| · · · | | Wentles | 1 | | |
|---|--|---|--|--|---|
| Type of Well ☑ Oil Well ☑ Gas Well ☑ Oil | | | 8. Well Name and No. PISTOLERO BVK FEDERAL 1H | | |
| Following completion of the involve testing has been completed. Final A determined that the site is ready for EOG Y Resources requests a the request for use of a central | final inspection. an amendment to our appr al tank battery. | roved APD for this well and fu | uture wells to n the lease. <i>I</i> | reflect 78 | And the operator has S from Maya - Riphep - Straw vold - Straw vold |

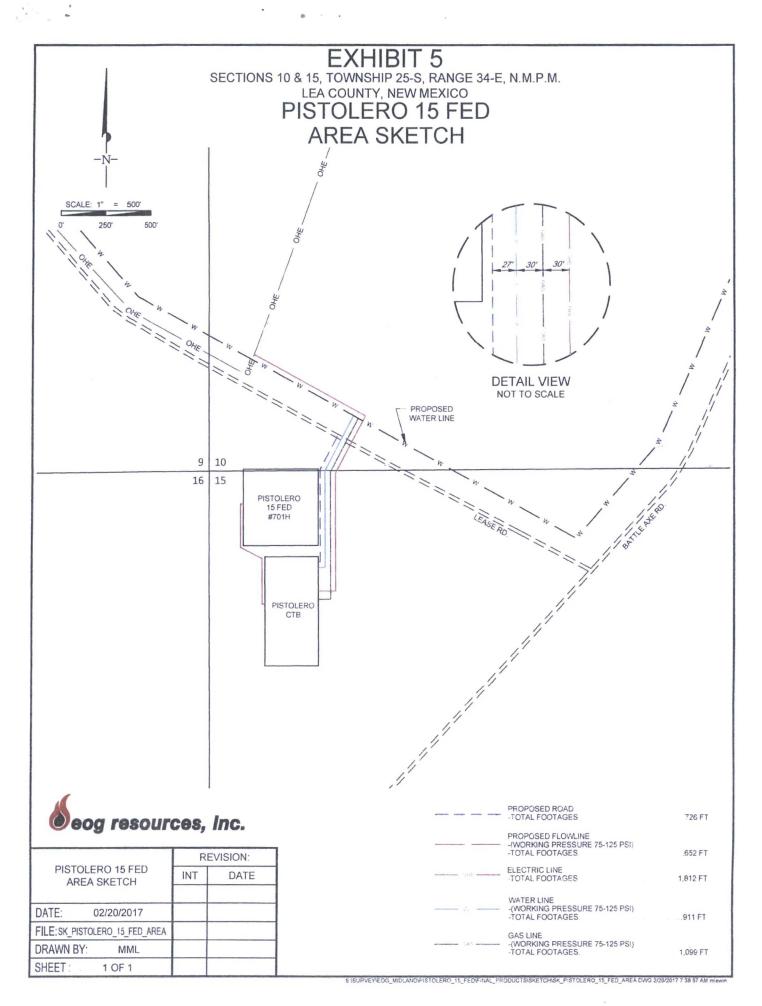
| · · · | | Wentles | 1 | | |
|---|--|---|--|--|---|
| EOG wants to include a 300x flowline and gas injection will renamed Pistolero 15 Fed 70 the same ditch in a 30 foot R(will run in a steel pipe north to produced water will run in a p ROW. The lease road to the ((Pistolero 15 Fed #701H) pad powerline in a separate 30 for | run along the west side of 1H) well pad and head so OW. Once produced water o our existing infrastructure oly pipe north to our existi CTB will run down the eas and come in to the SE co | uth to the CTB location. Both r and gas is separated at the e in a separate 30 foot ROW ing infrastructure in a separai t side of the Pistolero BVK Fi orner of the facility pad. We w | lines will be facility the ga and the te 30 foot ederal 1H vill have a | 12" Poly | |

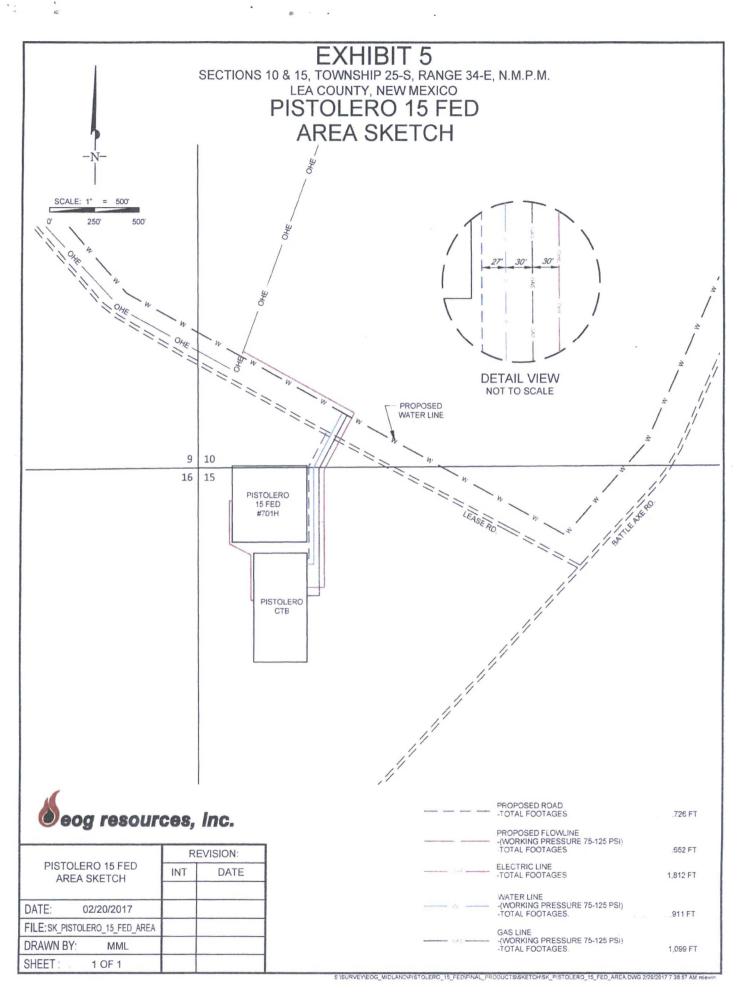
proposed gas and produced water lines. The attachment shows the location of well pad, CTB and pipeline ROWs etc
